# Technical Service Bulletin

**NUMBER:** 23-51-99

Instrument Panel Top Cover Not Properly Seated at Outboard Edges

2000 (PL) Neon

**FIGURE 1**

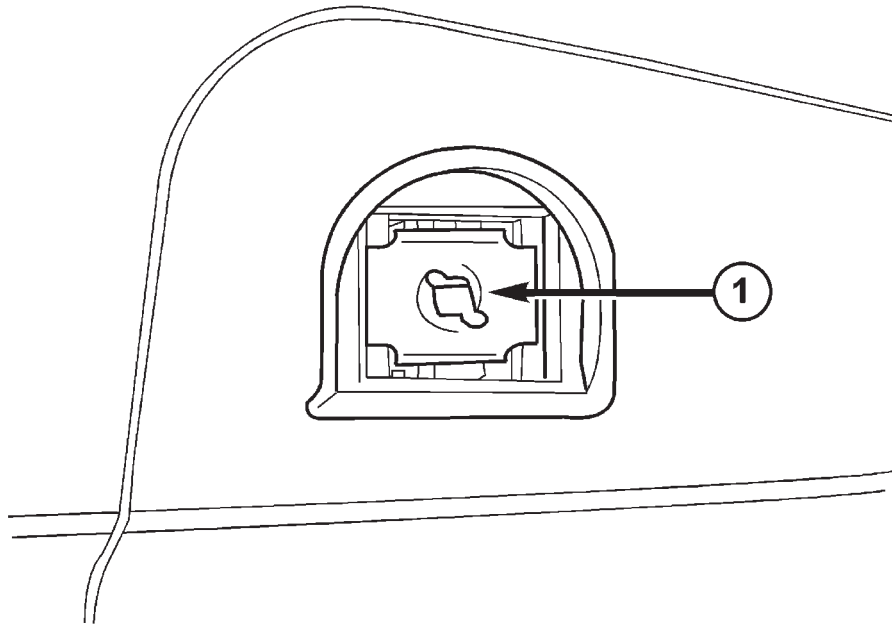
1. Pull back the weather seal and use a trim stick (special tool #C-4755) to remove the A-pillar moldings.
2. There are two screws securing the top center of the instrument panel top cover at the edges of the defroster duct opening. Back the two screws part way out until the top cover can be removed. Remove the instrument panel top cover using the trim stick.
3. If a retainer clip is not already present, insert the retainer clip into the square hole in the instrument panel substrate on each end. Ensure that the clip is properly orientated with the small flanges horizontal (Figure 1).

1-	RETAINER CLIP SHOWN IN PROPER POSITION - PASSENGER SIDE
----	---

**FIGURE 2**

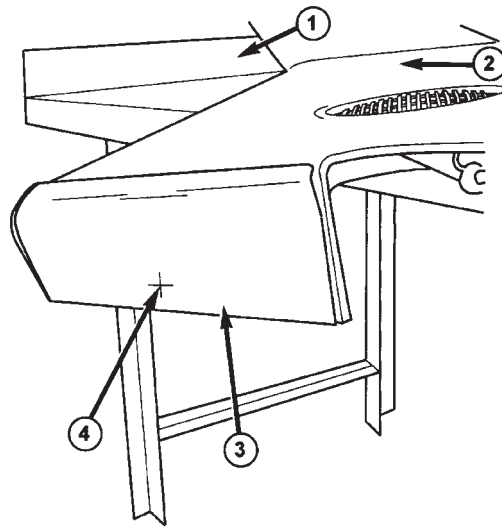
4. Cut out the templates supplied with the instruction sheet. The templates are labeled driver or passenger, ensure that the proper template is used or the hole will not be in the proper position. Tape the templates to the top cover (Figures 2 and 3).

1-	WORK BENCH
2-	TOP COVER
3-	PASSENGER SIDE TEMPLATE SHOWN ATTACHED TO TOP COVER
4-	MARK CENTER OF X FOR PROPER DRILLING LOCATION

5. With a pen or awl mark the center of the x of each template into the instrument panel top cover.
6. Remove the template and drill a 0.125 inch hole at the mark made in step 5.
7. Install the top cover and ensure that all clips are firmly seated. Install and torque the screws at the defroster vent to 20 in lbs.
8. Install the screws into the holes drilled in step 6 and torque to 20 in lbs. Figure 4 shows the passenger side screw properly installed.
9. Install the A-pillar moldings. Seat the weather seal around the A-pillar moldings.

**FIGURE 3**

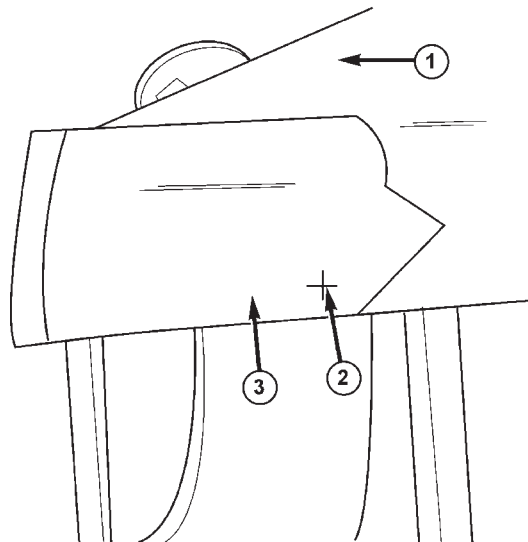
1-	TOP COVER
2-	MARK CENTER OF X FOR PROPER DRILLING LOCATION
3-	DRIVERS SIDE TEMPLATE SHOWN ATTACHED TO TOP COVER
